ALAMEDA COUNTY
HEALTH CARE SERVICES
AGENCY

Re: Work plan for the Kragen Auto site located at 4200 MacArthur Blvd., Oakland, California

This office has received and reviewed Harza Kaldveer's work plan, dated November 1993, for the installation and monitoring of three monitoring wells at the above site. This work plan is acceptable to this office with the following reminders/changes:

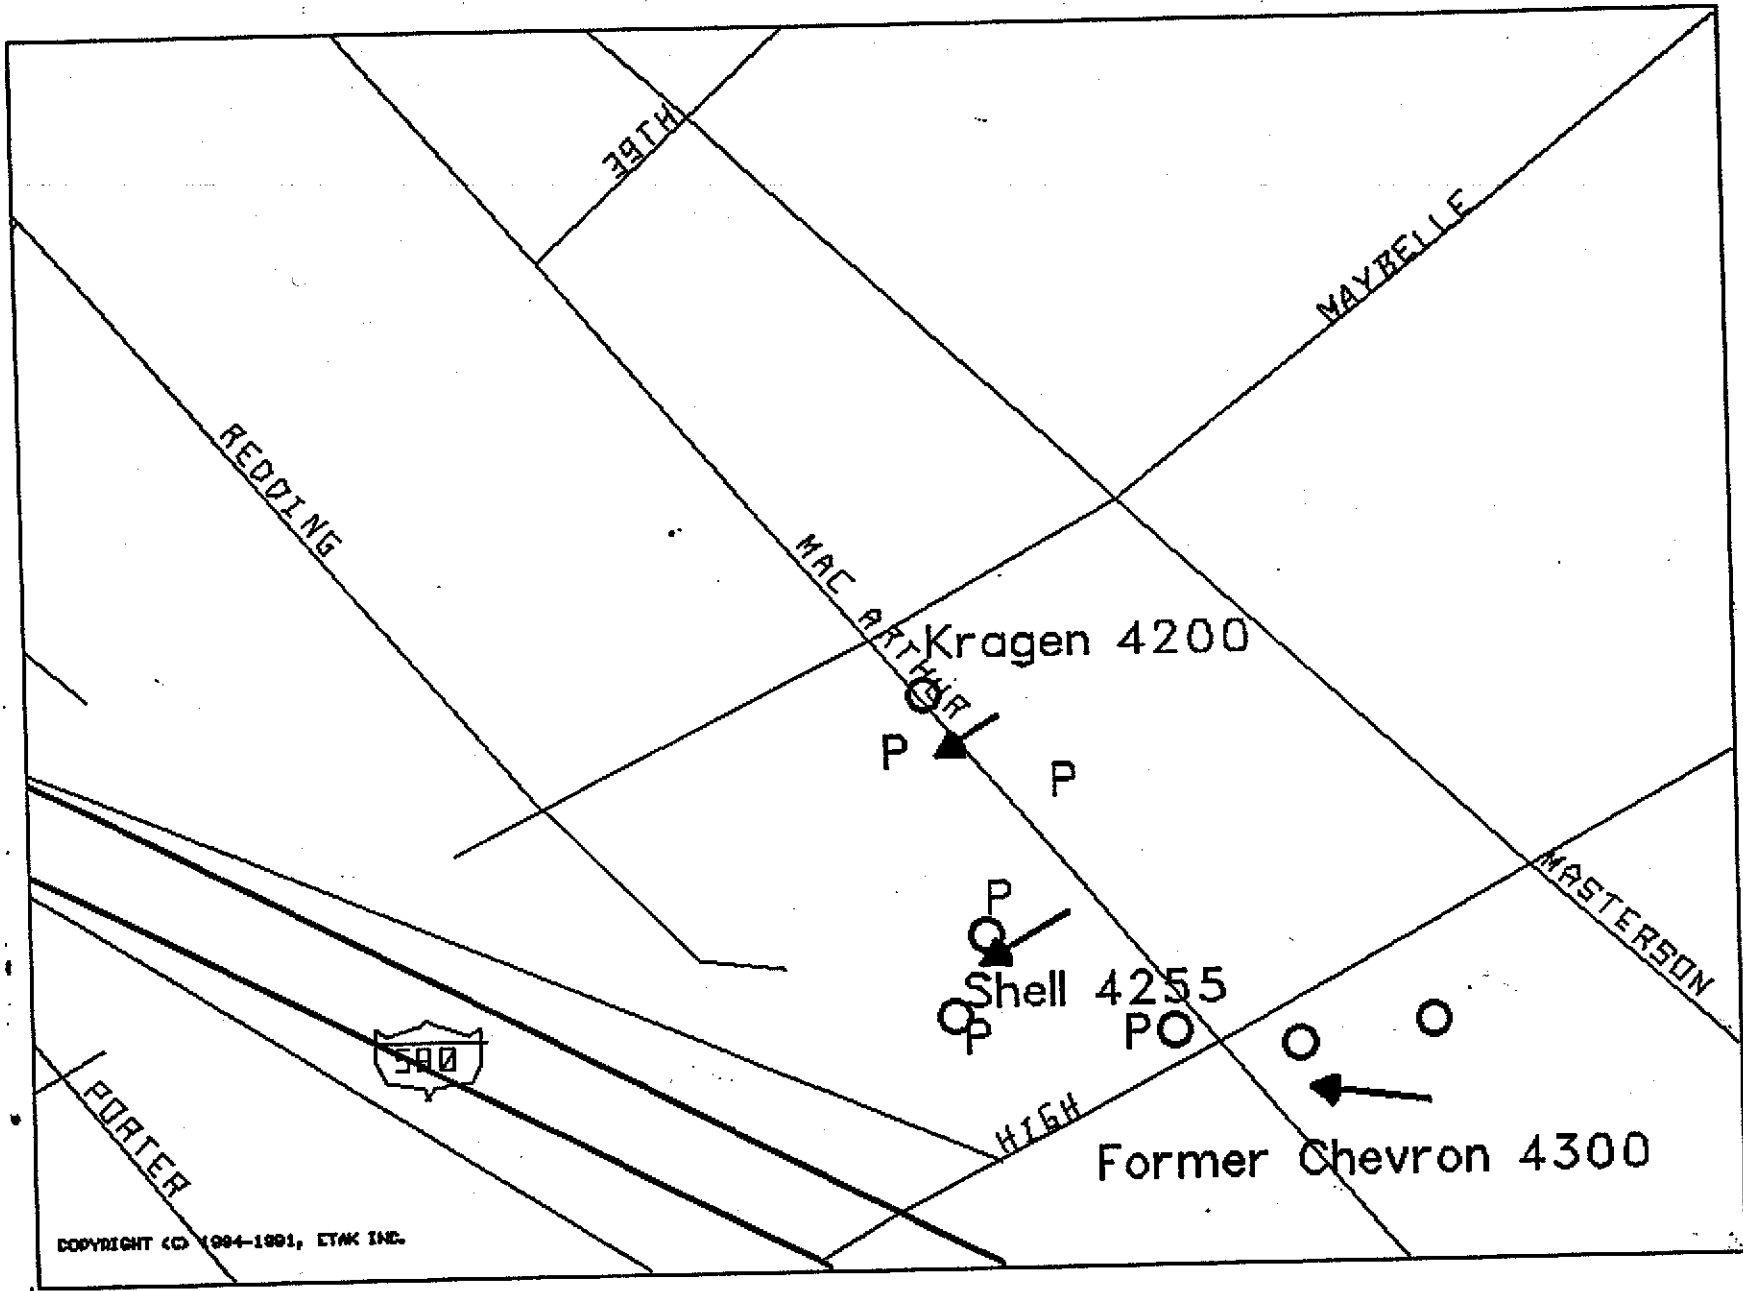
This office has reviewed reports of wells in the are of the above referenced site and looked at groundwater gradient. There are 2 wells in a former Chevron site 1 block away and a proposal for 3 additional wells at a Shell site only 1/2 block from your site. The gradient for Shell was established from previously installed wells. This information should allow you to install 1 well, as proposed on the attached map, in a verifiable down gradient direction from your former tank installation.
